Service Letter No. 425

**SUBJECT:** Lycoming Service Bulletin No. 298  
(Fuel and Oil Vent Restriction Requirement for AC Lightweight Diaphragm Fuel Pumps)

**DATE:** April 20, 1964 **Service Bulletin No. 298**  
**Approved by FAA**

**SUBJECT:** Fuel and Oil Vent Restriction Requirement for AC Lightweight Diaphragm Fuel Pumps

Figure 1. AC Fuel Pump with Vent in Upper Chamber

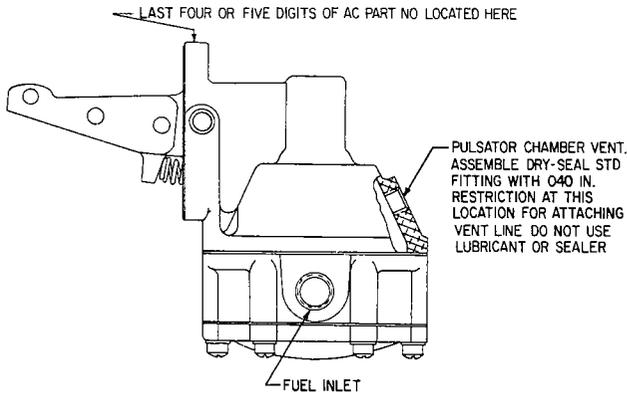
There have been several instances of oil seal failure in the lightweight aluminum AC diaphragm fuel pumps that resulted in engine lubricating oil being drained overboard through the fuel and oil vent lines. Early models of high pressure pumps used on fuel injected engines as well as low pressure fuel pumps used on carburetor engines are subject to this type of failure and must be modified by adding a vent restriction to prevent loss of lubricating oil.

The restriction can be installed anywhere from the upper chamber vent opening at the fuel pump and its line termination. In installations where a tee might be used to connect the fuel pump vent line with a common overboard line, the restriction must be installed between the fuel pump and the tee fitting. However, in most installations it will be found practical to install the restriction in the fitting that connects the overboard drain line to the upper chamber vent, as described herein.

All the fuel pumps affected by this bulletin have a single vent opening in the upper chamber as shown in figure 1, except the P/N 73870 (AC 5658696) which has

1. Determine applicability of this procedure by observing the AC fuel pump part number stamped on the upper edge of the mounting flange as shown in figure 1. Only the last four or five digits of the AC part number are stamped on the pump.

Figure 2. AC Fuel Pump with Two Vent Openings

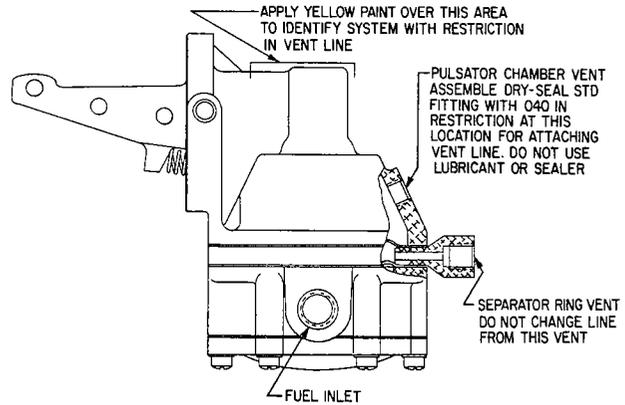
a vent opening in both the upper chamber and the separator ring as shown in figure 2. Regardless of which of the two types are found on the engine, the restriction described herein is to be installed only in the vent opening or line from the upper chamber; do not change the line connected at vent in separator ring.

4. Identify fuel system installation compliance with this service bulletin by yellow paint on top of the fuel pump as indicated in figure 2. If practical, also apply yellow paint at location of restriction in vent line. Enter notation in Engine Log Book to indicate compliance with this service bulletin.

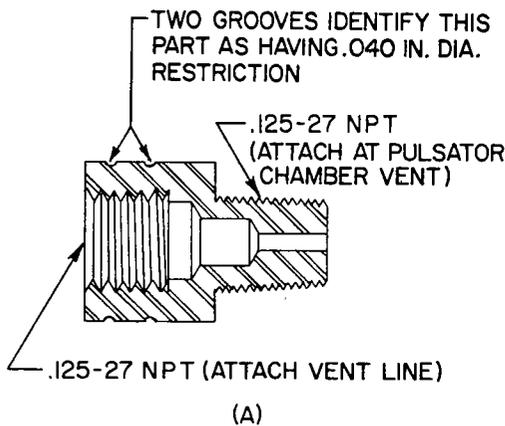
Although the restriction need not be installed at the location described in the following procedure, nevertheless it is necessary that the restriction consist of an approximate 0.040 inch diameter hole (No. 60 drill), by 1/4 inch in length, drilled in brass, aluminum, silver alloy solder or similar material that is not subject to corrosion by fuel or oil. Also, the restriction must be located between the fuel pump and any other fitting provided in the line for connection of additional vent lines.

Figure 3 (A). Lycoming P/N 75250 Overboard Drain Adapter

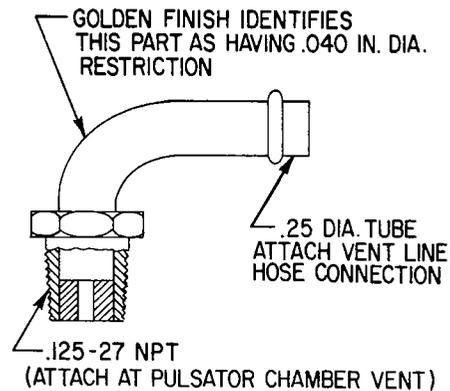
2. There are two restriction adapters available from Lycoming for installation in the tapped vent hole of the fuel pump. Lyc. P/N 75250 adapter which is generally suitable for most aircraft fuel system installations, and Lyc. P/N 75307 elbow adapter which is designed for installations where a hose coupling is required in the vent line, such as the Piper Comanche, Model PA 24-250. Both adapters, and their method of installation, are shown in figure 3.

Both adapters, P/N 75250 and 75307, incorporate a 0.040 inch diameter restriction and are identified as follows: The P/N 75250 adapter has two circular grooves around its hex portion. The P/N 75307 adapter can be identified by its golden color as contrasted with the white, cadmium plated elbow fitting that is usually installed at similar locations.

Figure 4. Typical Connector Fitting with .040 Restriction Installed

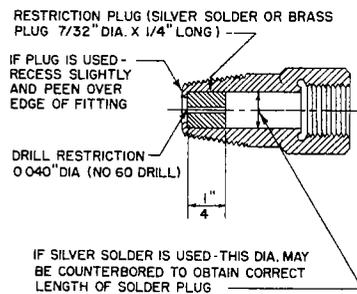
3. In some installations the connector between the fuel pump and vent line may be a standard flared fitting with a 7/32 inch diameter hole in the male end, similar to the one shown in figure 4. There are two methods (a or b) which a restriction may be installed in this fitting, or an alternate third method (c) for putting a restriction in the hose.

a. Fill the hole in the fitting with silver solder (if the fitting is steel) and drill a 0.040 inch diameter hole through the silver solder to form the restriction. If necessary, counterbore the solder filled

area to maintain the length of the restriction to 1/4 inch. Thoroughly clean the fitting and re-install it in the fuel pump.

b. Press a 7/32 inch diameter x 1/4 inch long plug in the hole of the fitting. Peen the end of the fitting to secure the plug and drill a 0.040 inch diameter hole (No. 60 drill) through the plug to form the restriction. 7/32 inch diameter bronze welding rod may be used to make the plug. Thoroughly clean the fitting and re-install it in the fuel pump.
